Virgil C. Summer Nuclear Station (VCSNS) Units 2 and 3
Combined License Nos. NPF-93 and NPF-94
Docket Nos. 52-027 & 52-028

Subject: VCSNS Units 2 & 3 LAR 13-31: Request for License Amendment and
Exemption: Relocation of Air Cooled Chiller Pump 3, VWS-MP-03

**License Amendment Request
Relocation of Air Cooled Chiller Pump 3
(LAR 13-31)**

Proposed Changes to Licensing Basis Documents:

UFSAR Section 9.2.7, Subsection 9.2.7.2.1, General Description

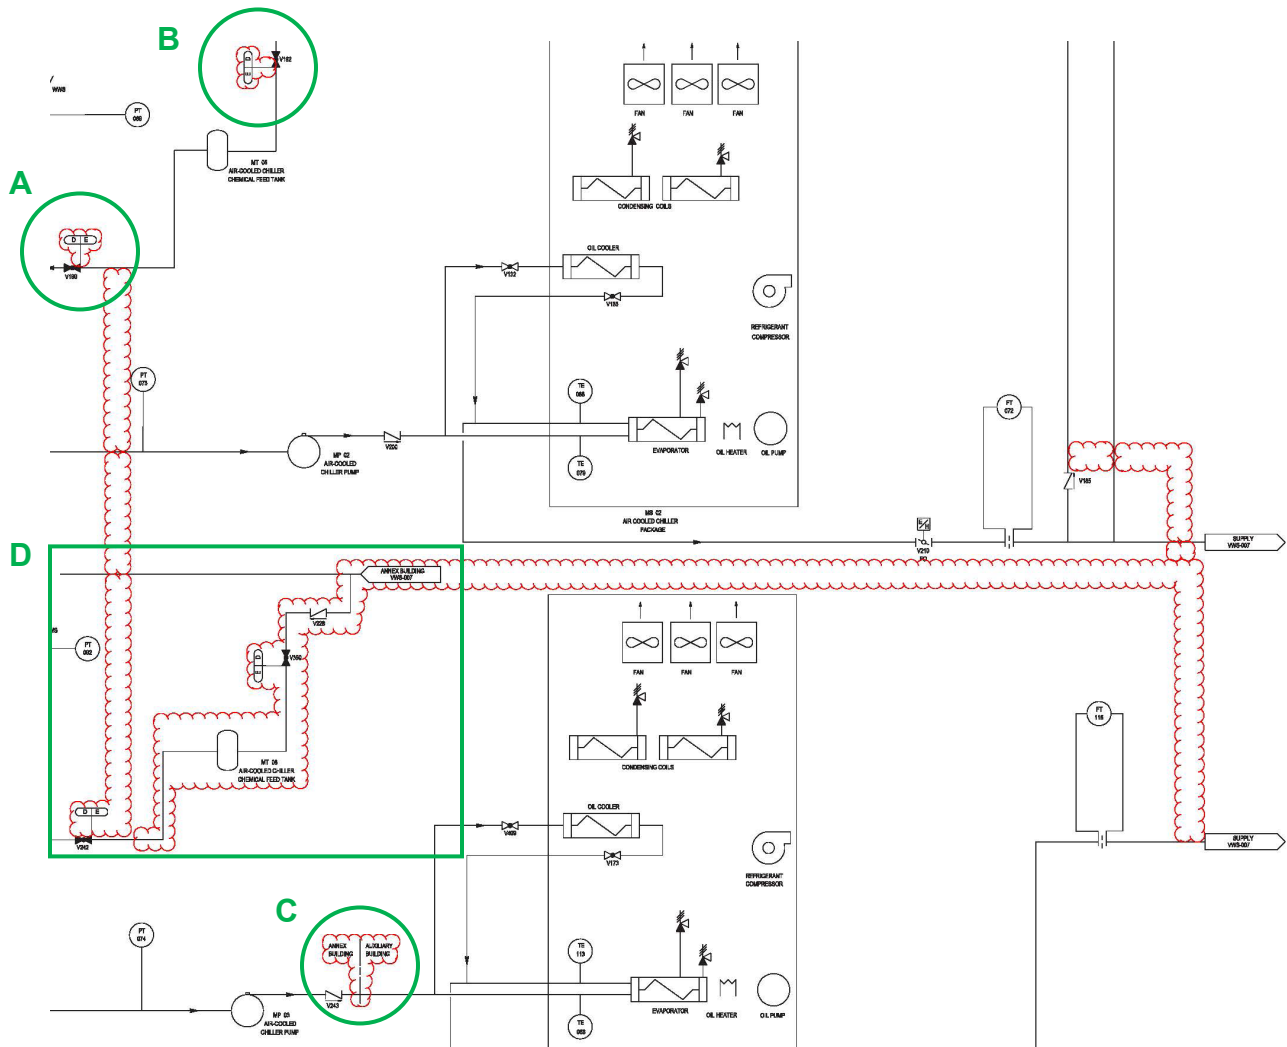
Revise Tier 2 information to reflect that each train of the low capacity VWS subsystem loop has its own chemical feed tank versus a common chemical feed tank. The statement regarding the location of the chiller pumps and expansion tanks relative to the chillers is also removed.

The low capacity subsystem consists of two 100-percent capacity chilled water loops. Each loop consists of a chilled water pump, an air-cooled chiller, an expansion tank, a chemical feed tank, and associated valves, piping, and instrumentation. The subsystem is arranged in two independent trains with separate supply and return headers. ~~The subsystem is provided with a common chemical feed tank.~~ The subsystem provides a reliable source of chilled water to the main control room (MCR) and control support area (CSA) HVAC subsystem, and the Class 1E electrical equipment room HVAC subsystem. This system configuration provides 100-percent redundancy during normal plant operation and following the loss of offsite power. The air-cooled chillers of the low capacity subsystem are located on the auxiliary building roof. ~~The chilled water pumps and expansion tanks are located in the auxiliary building below the chillers.~~

UFSAR Section 9.2, Figure 9.2.7-1 (Sheet 1 of 4), Simplified Central Chilled Water System Piping and Instrumentation Diagram (REF) VWS 006

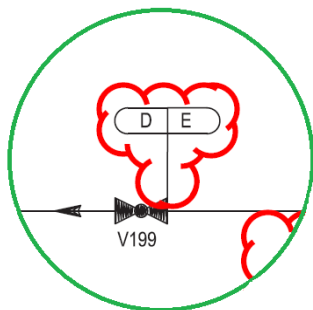
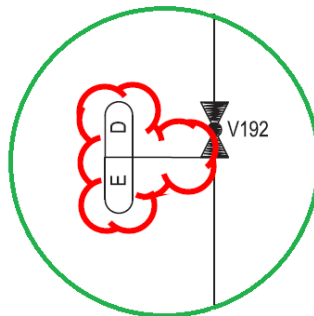
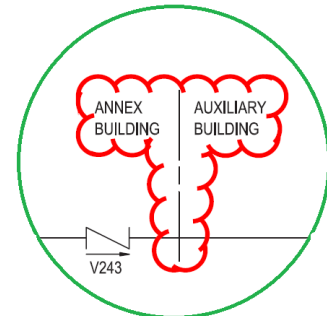
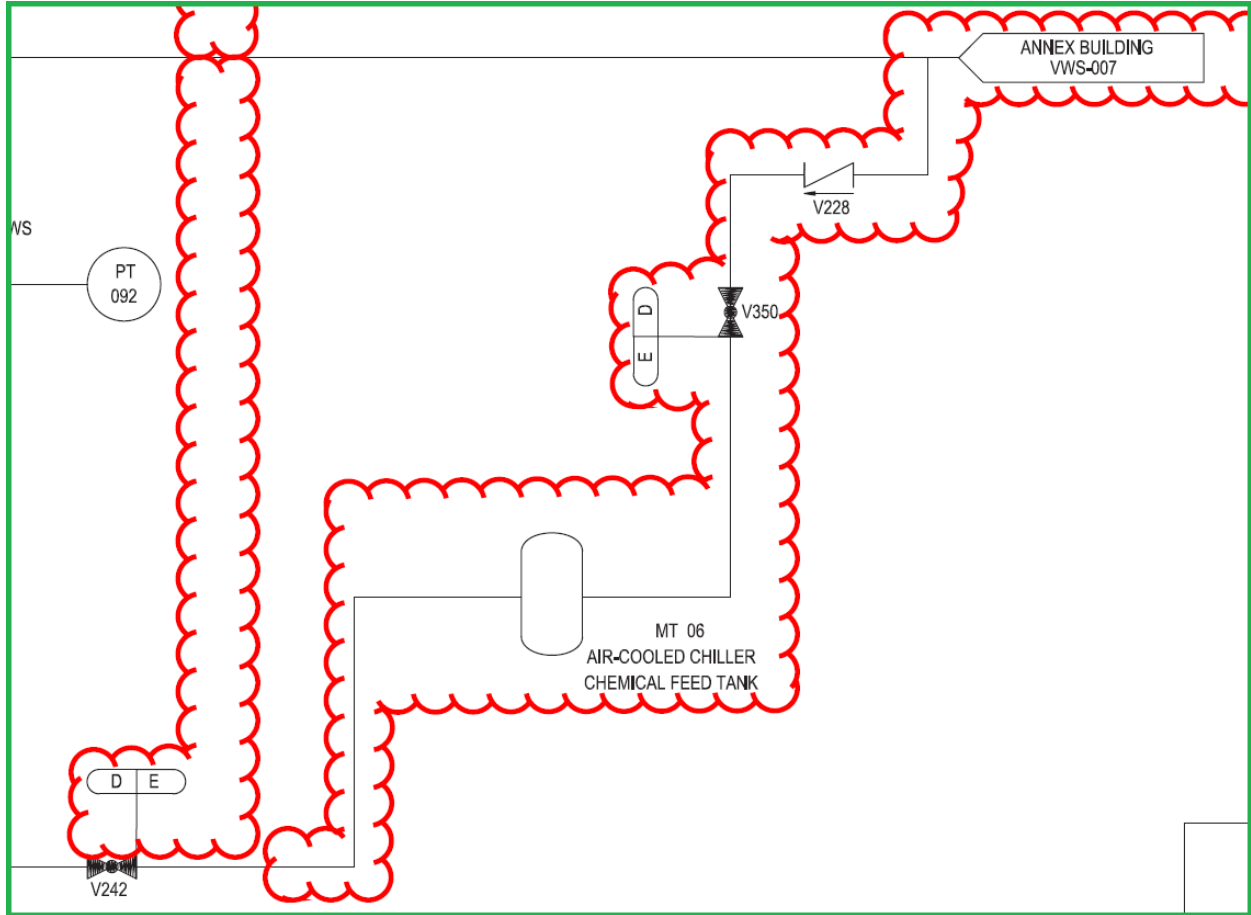
- Revise Figure 9.2.7-1 (Sheets 1 and 2 of 4) to:
 - Indicate that pump VWS-MP-03 and its associated equipment are located in the Annex Building.
 - Depict the revised configuration of the equipment associated with the relocation of the expansion tank and the new chemical feed tank associated with VWS-MP-03.

Revise UFSAR Tier 2 Figure 9.2.7-1 (Sheet 1 of 4) Title, as follows:

~~Inside Auxiliary Building~~ Simplified Central Chilled Water System Piping and Instrumentation Diagram (REF) VWS 006

Revise UFSAR Tier 2 Figure 9.2.7-1 (Sheet 1 of 4), as depicted below (See detailed blow-ups below):

UFSAR Section 9.2, Figure 9.2.7-1 (Sheet 2 of 4), Simplified Central Chilled Water System Piping and Instrumentation Diagram (REF) VWS 006

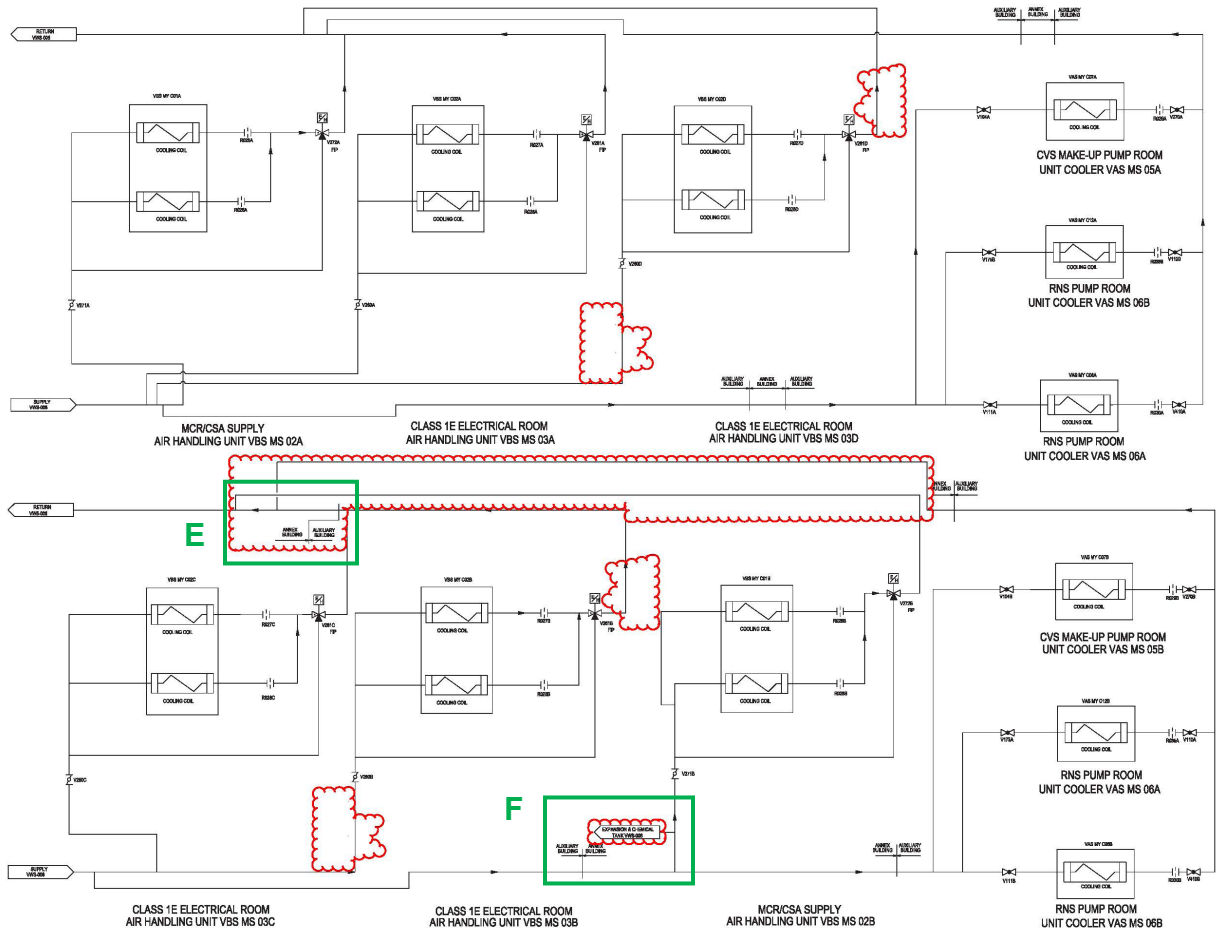
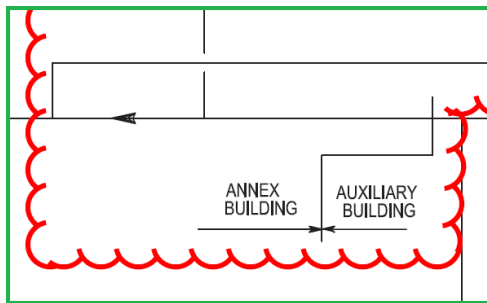
Revise UFSAR Tier 2 Figure 9.2.7-1 (Sheet 2 of 4), as depicted below (See detailed blow-ups below):
